Re: Docket ID No. EPA-R08-OAR-2011-0851, Comments on Proposed Regional Haze Federal Implementation Plan for Montana

WildEarth Guardians submits the following comments on the U.S. Environmental Protection Agency's ("EPA's") proposed regional haze federal implementation plan ("FIP") for the State of Montana. This proposal was published in the Federal Register on April 20, 2012. *See* 77 Fed. Reg. 23988 (April 20, 2012) (hereafter "Proposed Rule").

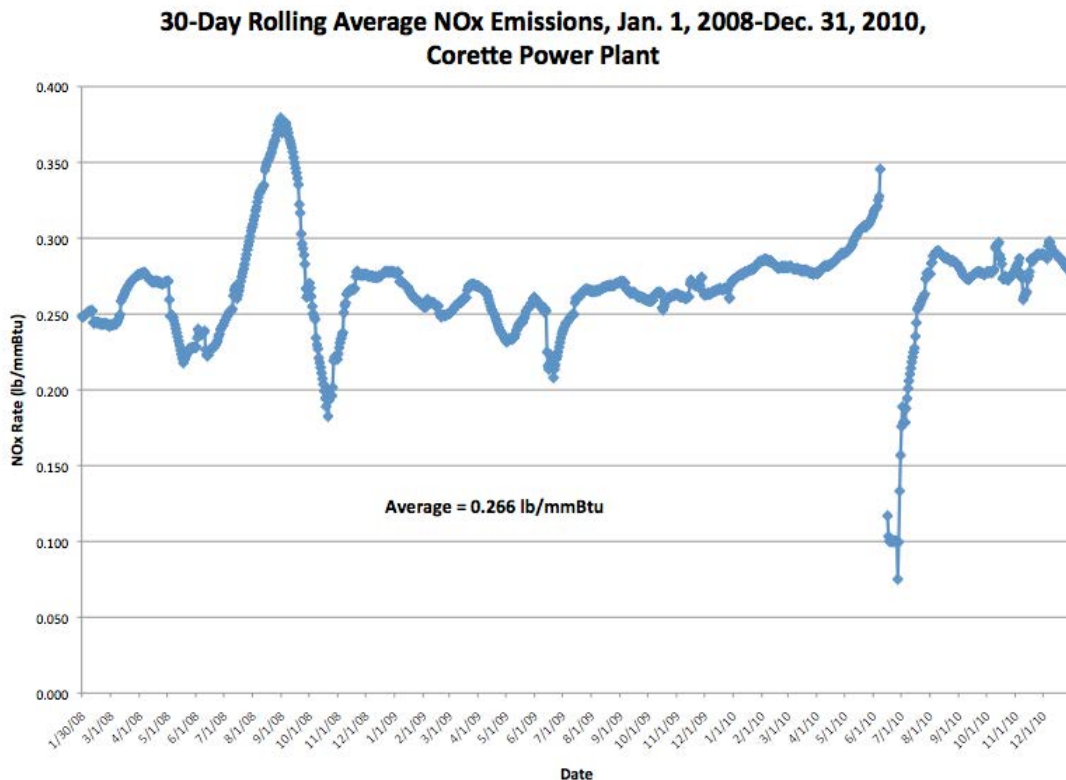
Besides this, it is troubling to see that under the EPA’s proposed BART for Corette, the facility will actually be allowed to emit more NO_x and sulfur dioxide (“SO₂”) than what it is currently emitting. This casts further doubt on the credibility of EPA’s BART determination for Corette. Indeed, under the Agency’s proposed BART, NO_x emissions would be limited to no more than 0.40 lbs/mmBtu on a 30-day rolling average basis and SO₂ emissions would be limited to no more than 0.70 lbs/mmBtu annually. No additional controls would be required to achieve

these limits. However, data submitted by the operator of Corette to the EPA’s Air Markets Program website shows that between 2008 and 2010, the baseline years that EPA relied upon in assessing NOx and SO₂ emissions from the Corette power plant, the facility has consistently achieved far lower emission rates.⁷

For example, with regards to NOx emissions, EPA’s database shows that between 2008 and 2010, Corette achieved an average 30-day rolling average emission rate of 0.266 lbs/mmBtu. As the chart below shows, during the baseline years of 2008-2010, 30-day rolling average NOx emissions were consistently far below 0.40 lbs/mmBtu.⁸
